**ADDENDUM NO. 2**  
**Bid Reference No. MCN.0025**  
**GPR Event ID PE-61100-NONST-2025-000000066**

**PAVING, LIGHTING AND MARKINGS FOR  
RUNWAY 5 EXTENSION**

**Middle Georgia Regional Airport (MCN)**

**Bid Advertisement Date: April 21, 2025**  
**Addendum No. 2 Issue Date: May 09, 2025**

**RUNWAY DESIGNATION MARKINGS**  
SCALE: NTS

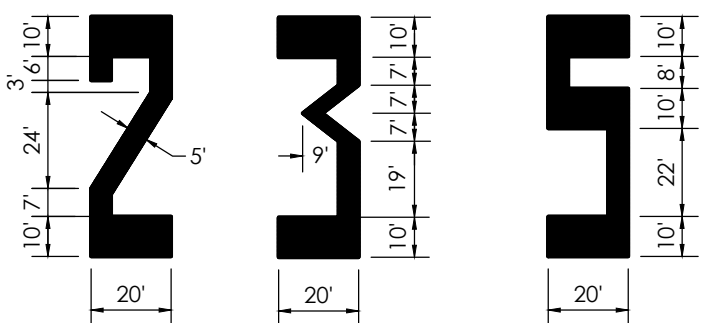
10. **Plan Sheet C150.** The "Runway Designation Markings" and the "Surface Painted Holding Position Sign Layout" details were updated to reflect the correct runway designation numerals.

### DISPLACED THRESHOLD MARKING DETAIL

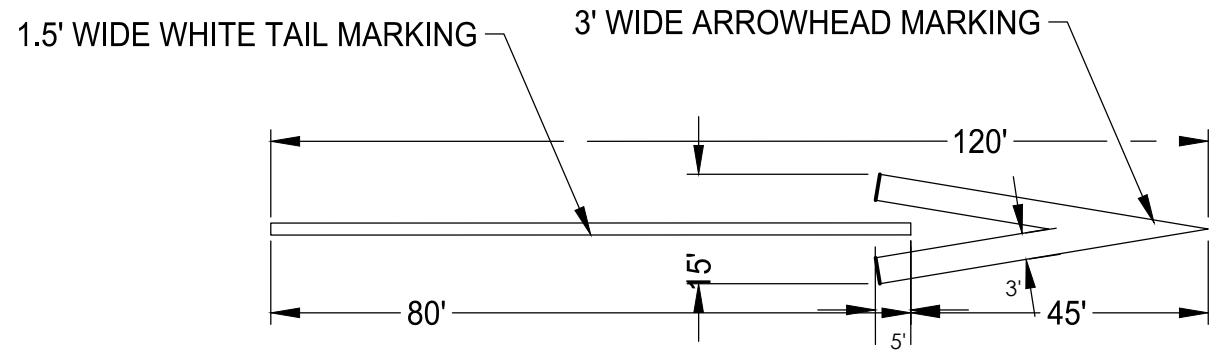
11. **Plan Sheet C151.** The "Displaced Threshold Marking" detail was updated to reflect the correct

SHEET:  
**EA-504**

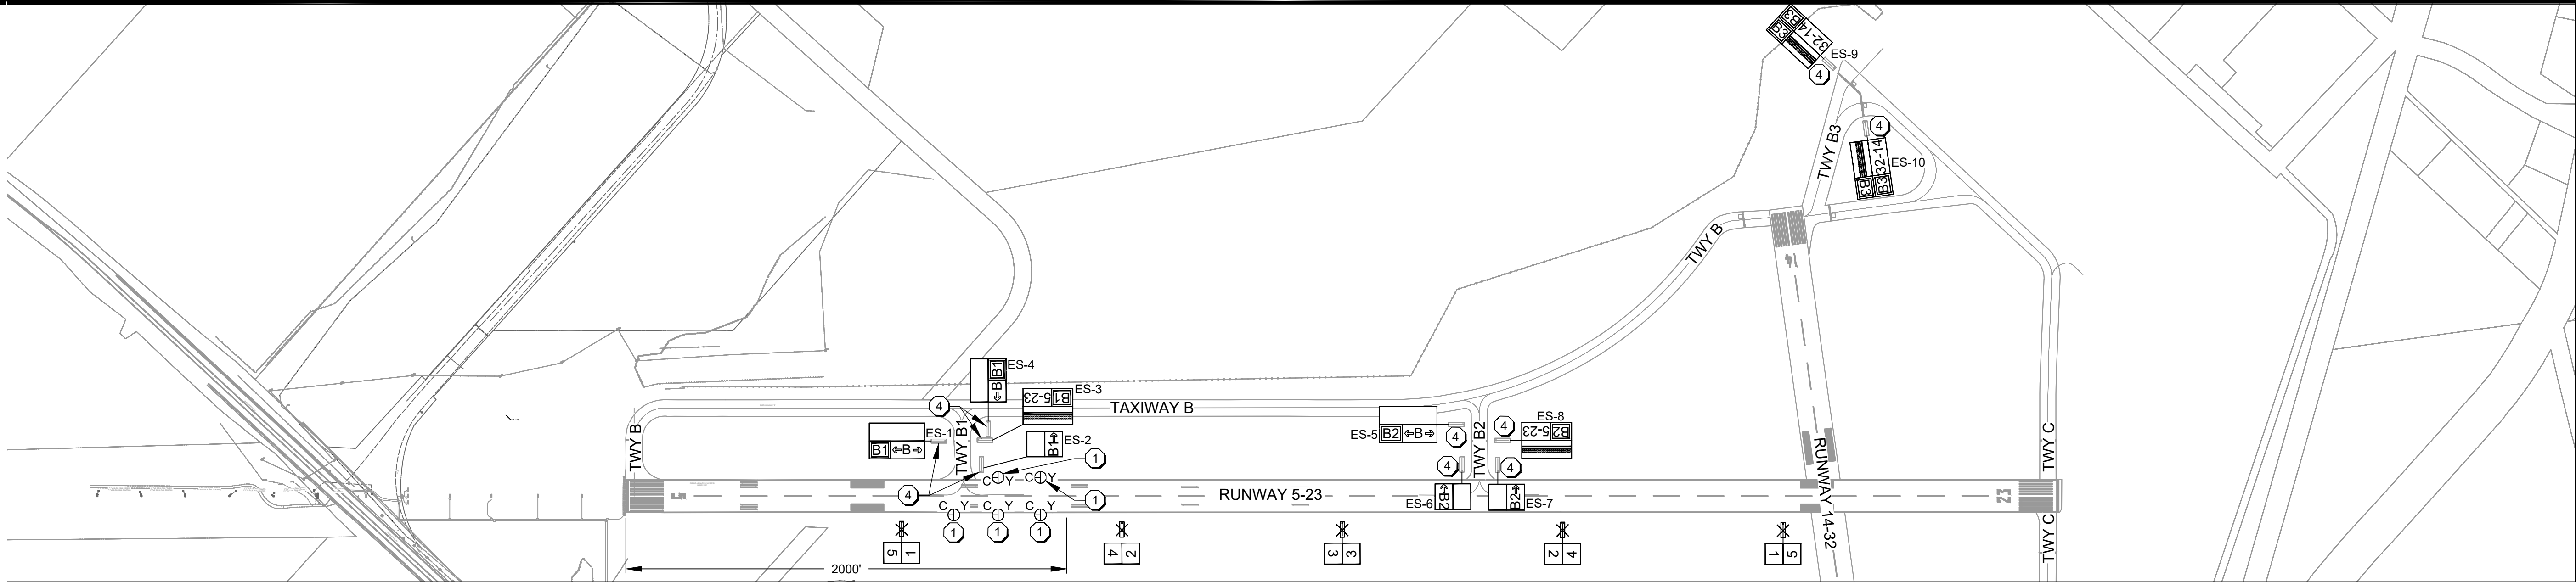
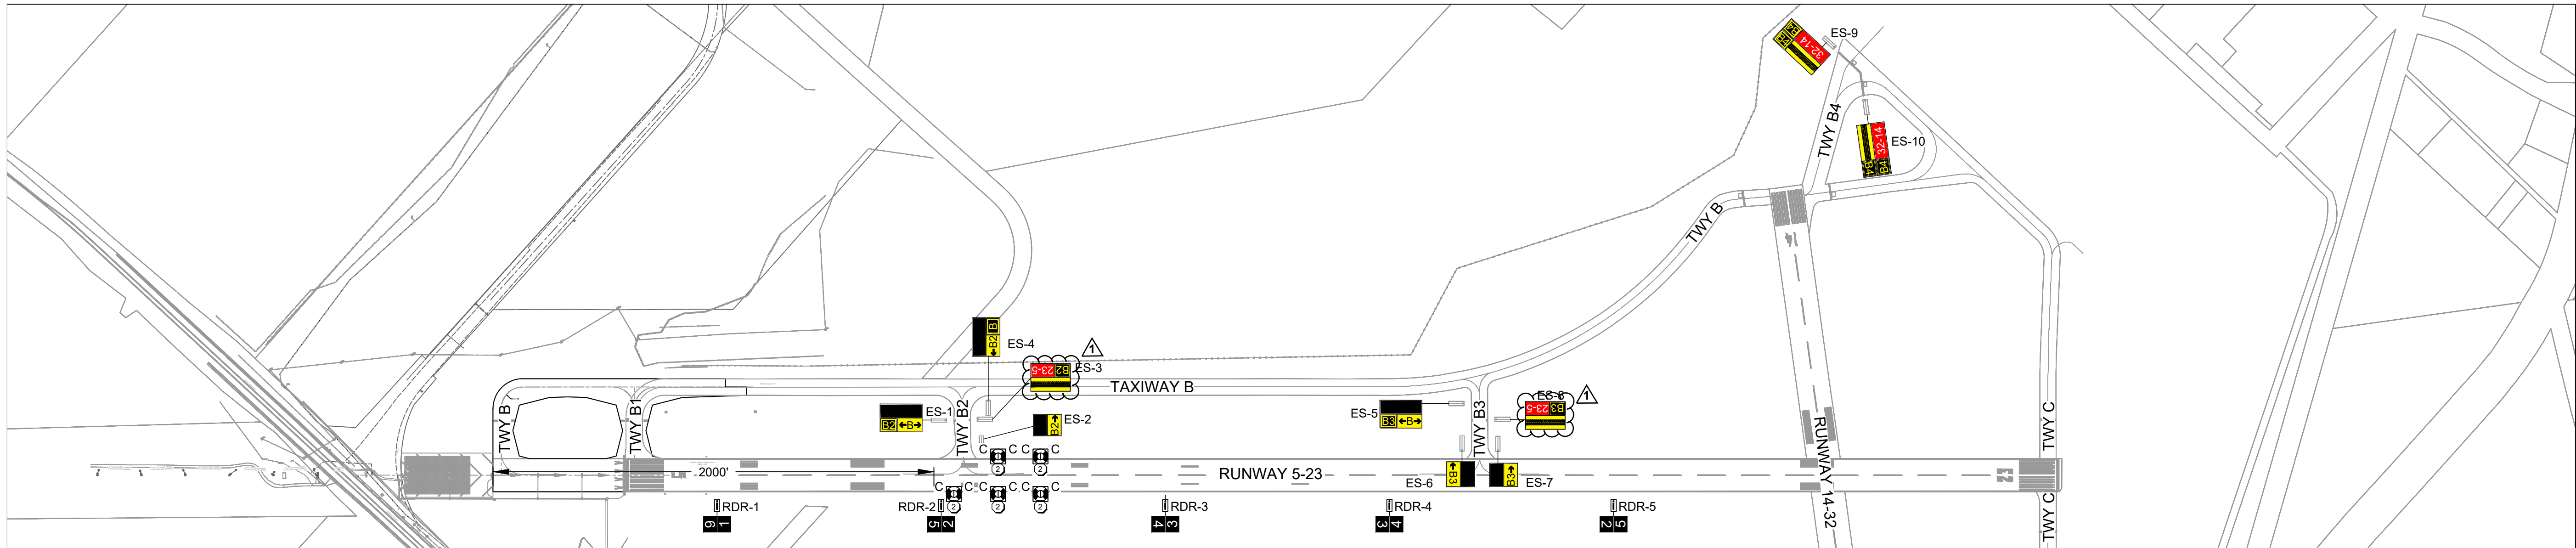
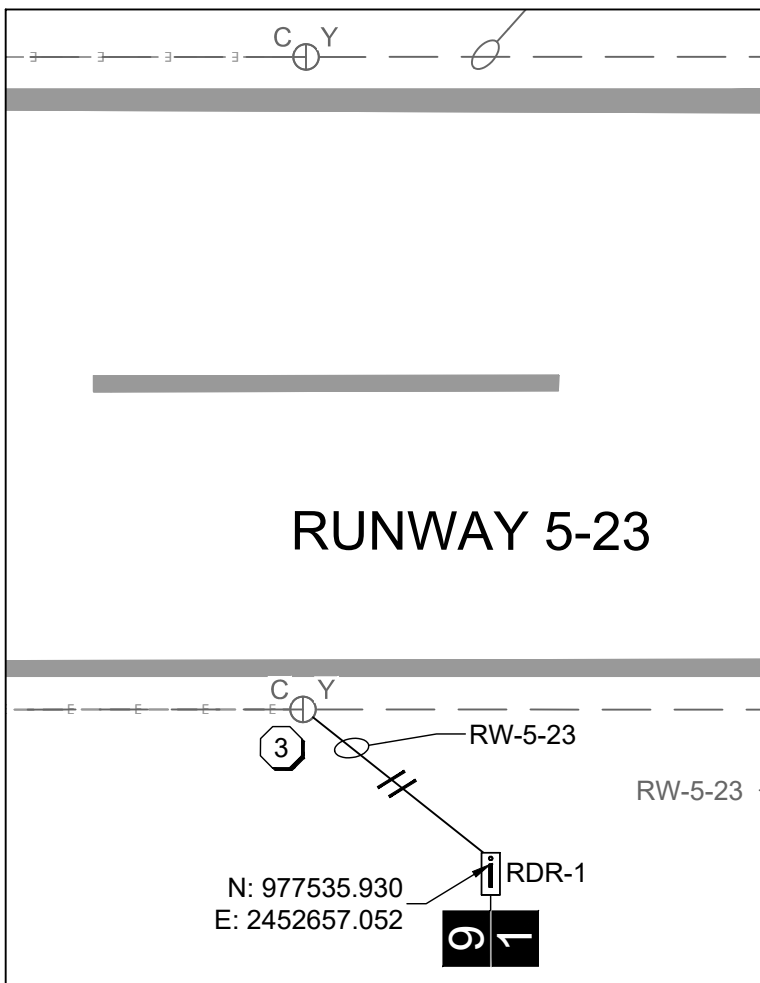
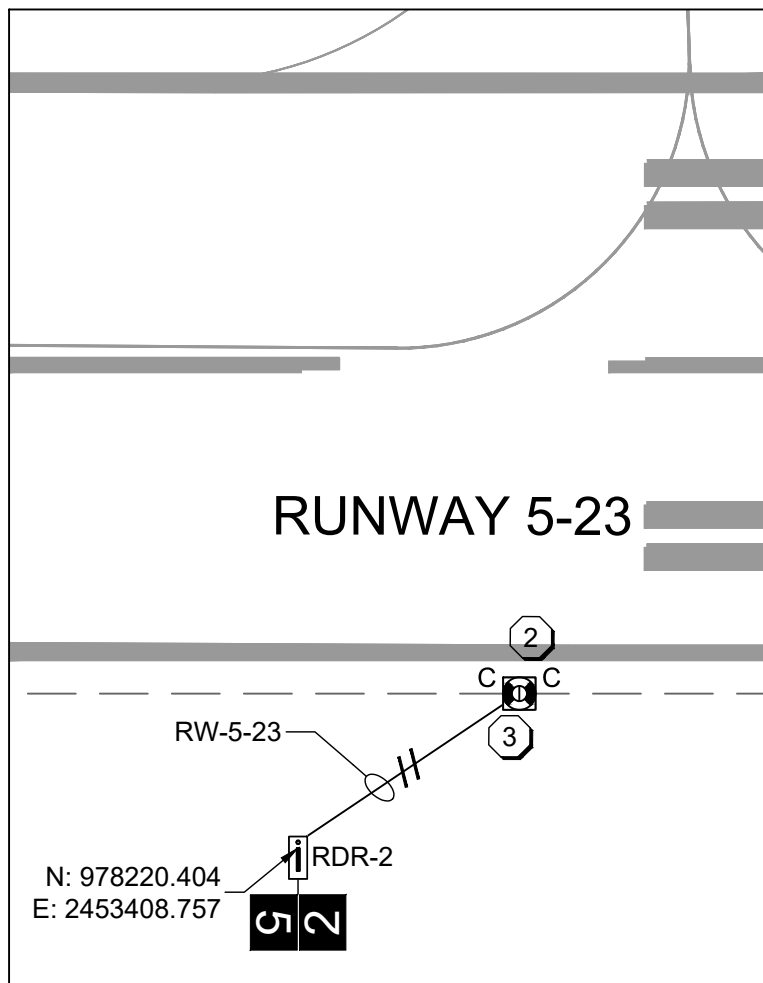
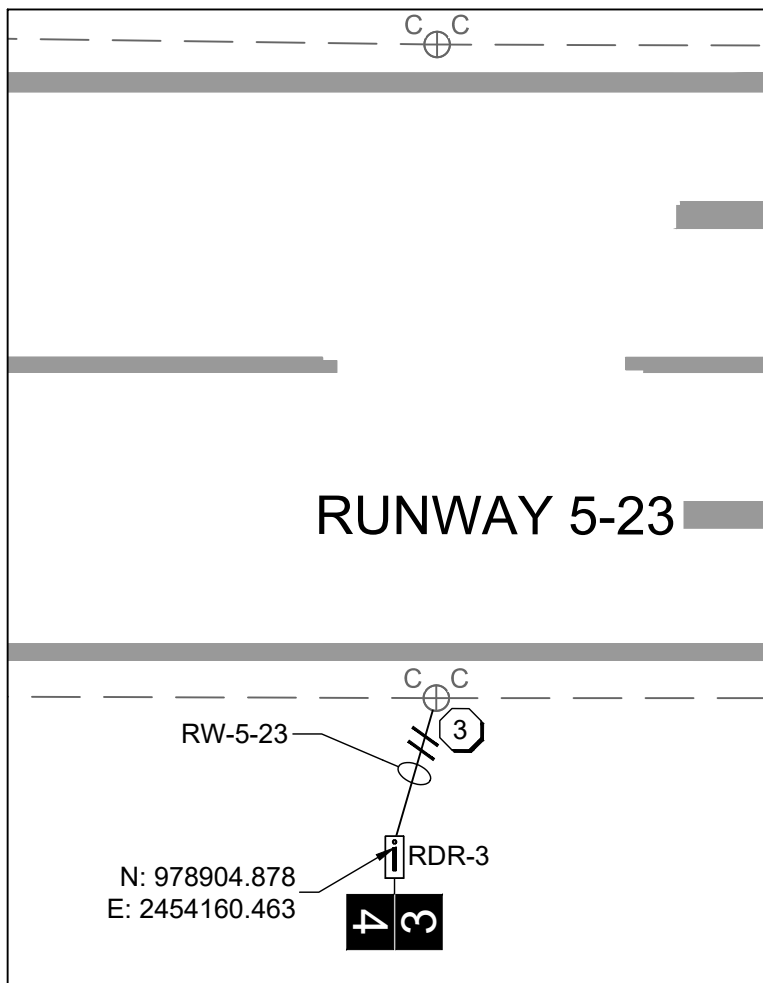
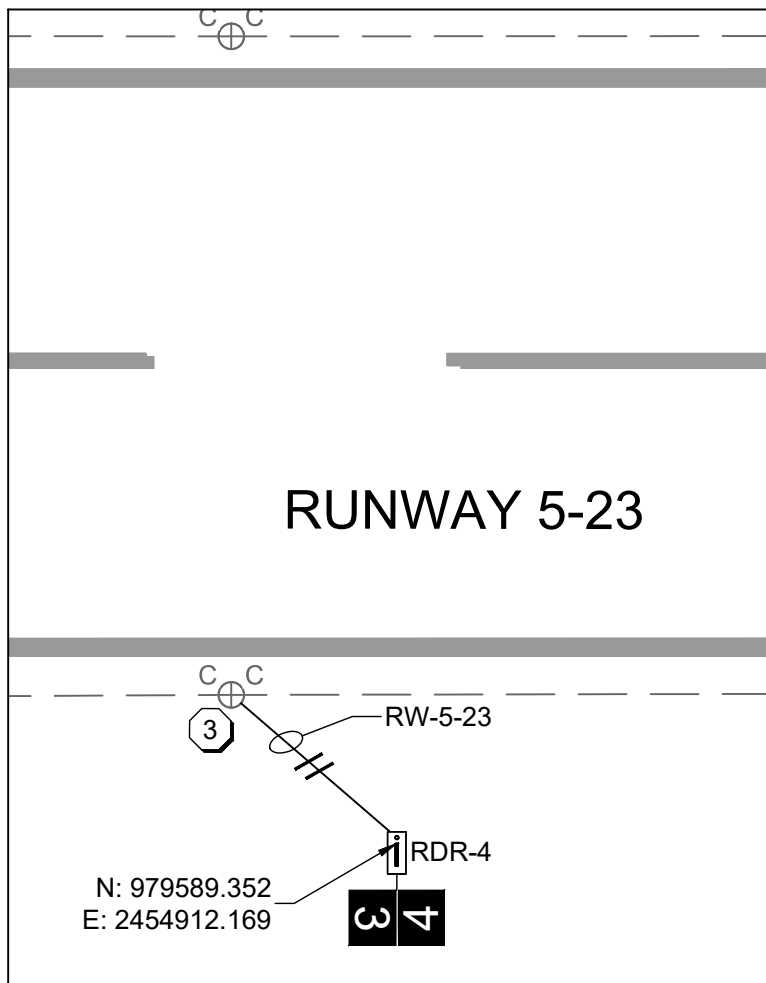
- 14. Plan Sheets EA-502, EA-504 and EA-805.** The hold signs were updated for the updated “5-23” runway designation.
- 15. Technical Specifications (P-152).** Section 152-1.2b “Borrow excavation” was added, Section 152-2.3 was revised to include information for offsite borrow sources, Sections 152-3.3 and 152-4.2 were added and “Offsite Borrow” was added to Method of Measurement and Basis of Payment.
